# COUNCIL ASSESSMENT REPORT

Panel Reference	PPSSTH-73 – WAGGA WAGGA
DA Number	DA20/0708
LGA	Wagga Wagga
Proposed Development	Hospital campus car parking works, including new multi-storey car park, two at-grade car parks, access upgrades and part closure of Doris Roy Lane
Street Address	260 Edward St WAGGA WAGGA NSW 2650
Applicant/Owner	Health Infrastructure / Health Administration Corporation
Date of DA lodgement	15 December 2020
Total number of Submissions Number of Unique Objections	<ul style="list-style-type: none"> <li>5 (Transport for NSW, Essential Energy, Riverina Water, 2 public submissions)</li> <li>2 (public submissions)</li> </ul>
Recommendation	Approval
Regional Development Criteria (Schedule 7 of the SEPP (State and Regional Development) 2011	<p>Crown development over \$5 million</p> <p>Development carried out by or on behalf of the Crown (within the meaning of Division 4.6 of the Act) that has a capital investment value of more than \$5 million.</p>

Report prepared by	Cameron Collins
Report date	5 February 2021

The following diagram illustrates the recommendation:

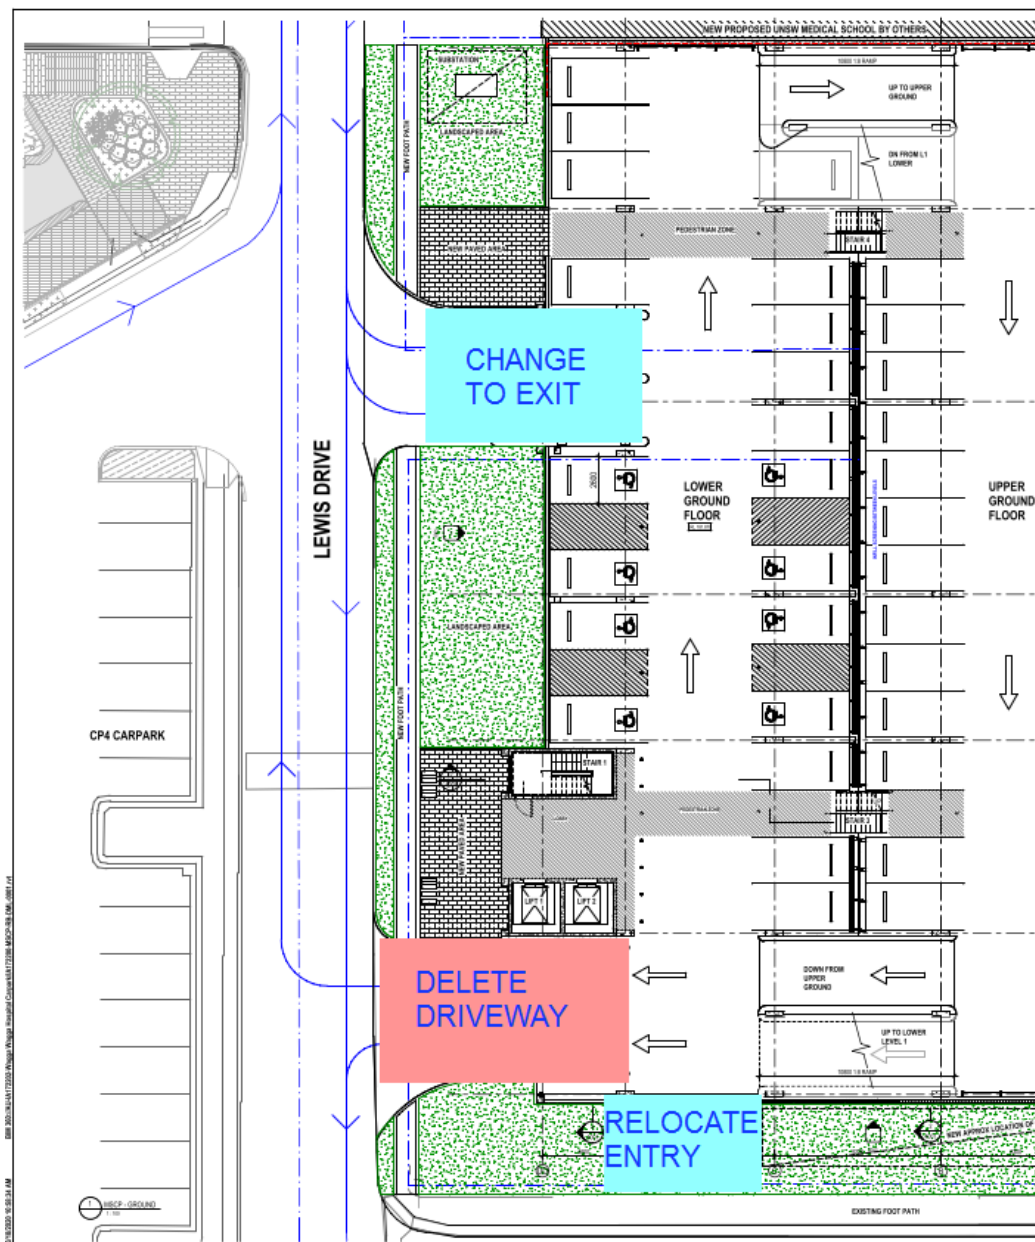
- TfNSW recommendation - relocation of the southern driveway to Yabtree Street for entry to MLCP and conversion of northern driveway to Lewis Drive for egress.
- TfNSW alternate recommendation (on the basis that the first recommendation is not accepted by the proponent) - the swapping of the existing driveways (entry to the south and egress to the north).

The recommendations are supported for the following reasons:

- The relocation of the entry driveway to Yabtree Street will encourage and improve the redistribution of access via Murray Street lights to the carpark. This will reduce the focus of access being from the Edward Street intersection (and impact on the existing limited right turn lane in Edward Street).
- The further separation of driveways will better distribute traffic from the entry/exit points. Traffic that would have used the Lewis Drive entry would be redistributed to the Yabtree Street entrance resulting in each road receiving a more balanced traffic flow.
- The relocation of the entry to Yabtree Street (or at least further to the south) will reduce the potential for queuing across the existing access to the open carpark on the western side of Lewis Drive. It will also reduce the risk of queuing back to Edward Street.

It is recommended that a condition of consent require that, prior to the commencement of works, revised plans be provided identifying the reconfiguration of the proposed access driveways on Lewis Drive so that the northern driveway functions as the egress and the southern driveway is relocated to operate as an entry from Yabtree Street.

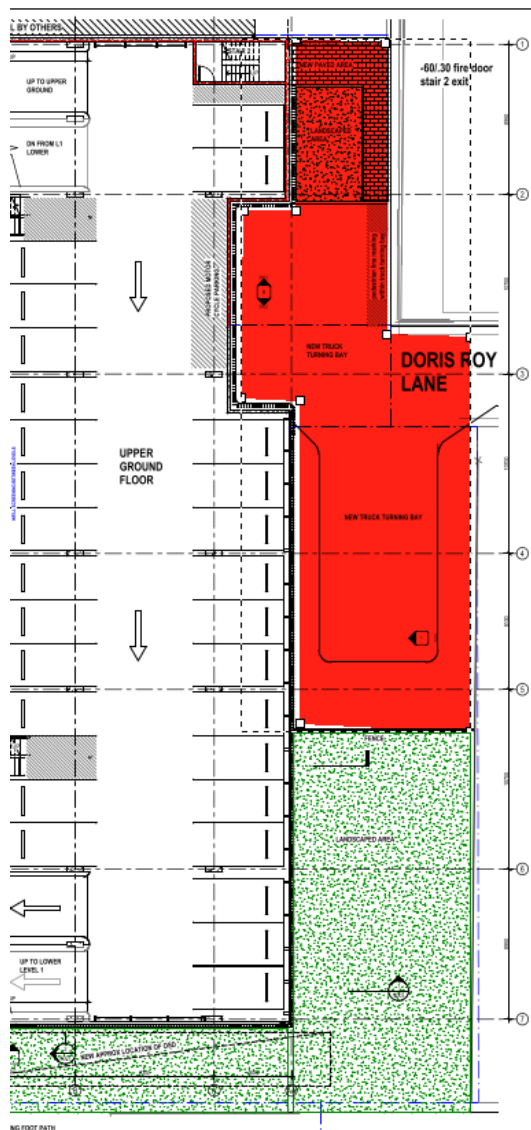
- a) installation of a wombat crossing in Lewis Drive adjacent to the proposed foyer of the MLCP to provide improved safety for pedestrians crossing Lewis Drive at this location to access the main public entry to the Hospital.
- b) installation of enhanced threshold treatment at the approaches of the shared zone (at the intersections of Lewis Drive with Edward Street and Peck Street) to reinforce the status of the area as a low speed environment.

It is recommended that a condition of consent require that, prior to the commencement of works, revised plans be provided identifying the enhancement of the existing shared zone adjacent to the Multi Level Car Park building through the installation of a wombat crossing in Lewis Drive adjacent to the proposed foyer and the installation of enhanced threshold treatment at the commencement of the shared zone (at the intersections of Lewis Drive with Edward Street and Peck Street).
